SUBDIVISION COMMITTEE
METROPOLITAN AREA PLANNING COMMISSION

STAFF REPORT
(Preliminary Plat)

CASE NUMBER: S/D 99-87 -- SAWMILL CREEK ADDITION

STAFF REPORT
(Final Plat, Preliminary Plat Approved 12/2/99)

VICINITY MAP

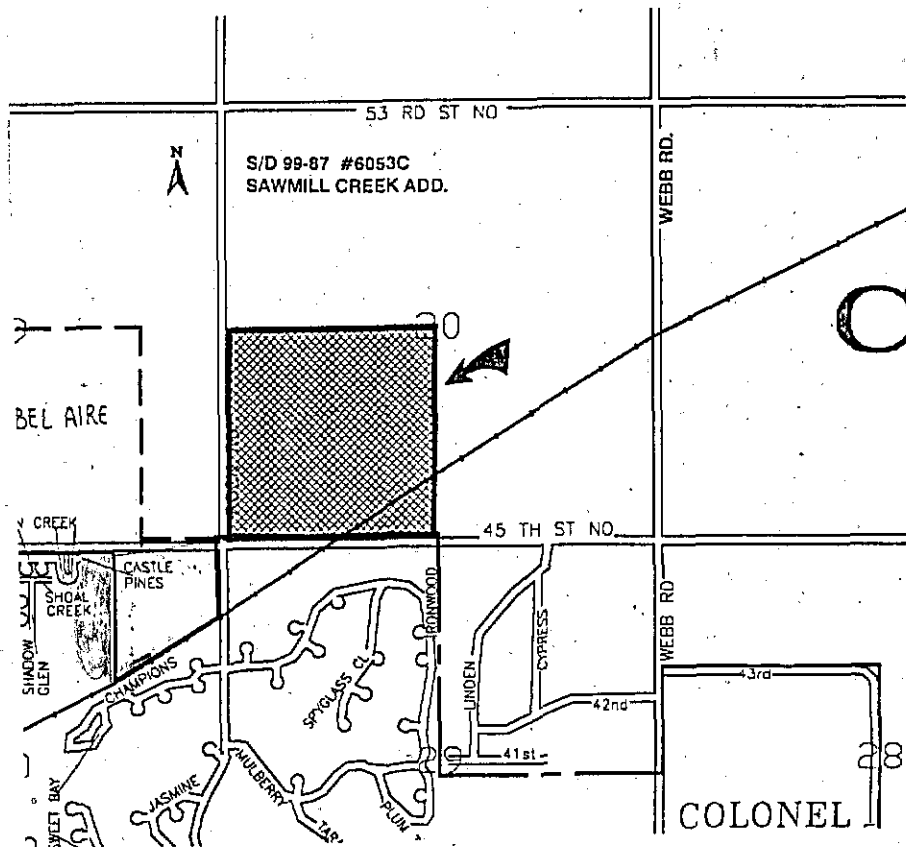
*off-site easement
no drainage concept
SS layout*
